**CLARIFICATIONS FOR 5140400-04 – SUPPLY AND INSTALLATION OF PRIMARY SUBSTATIONS (PHASE 1) -
DESIGN-BUILD FOR KORLE-GONNO, KOTOBABI, KANDA & LEGON**

BID REFERENCE: 5140400-04/IFB/CB/03/19

156

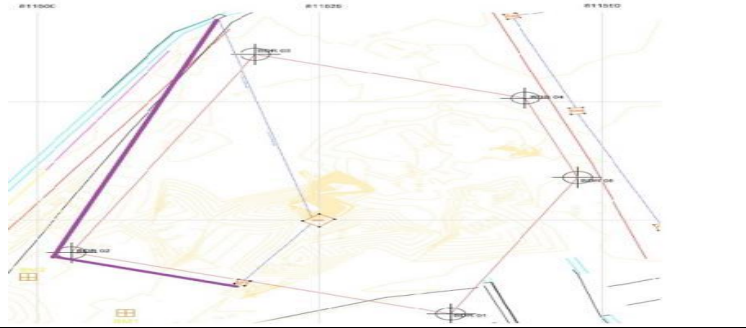
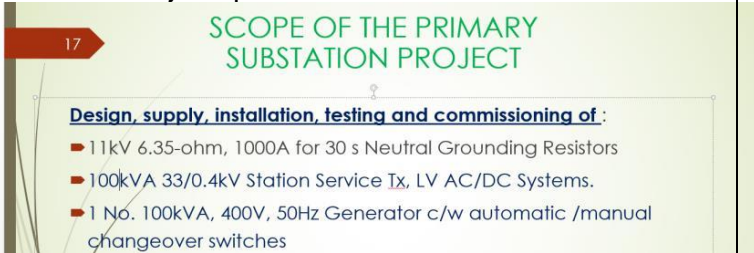
There is a discrepancy between the price schedule item 2,11 "TERMINATION KITS FOR 33kV & 11kV INTERCONNECTING CIRCUIT CABLES and the Single Line diagram Drawings of the substation. See below the summary.

Please confirm that the quantities to take into account are the ones of the SLD. In that case confirm whether the price schedule can be modified or you will send a new one.

Please use price schedule quantities. However, disregard item 2.11.2 on price schedule of UGTH
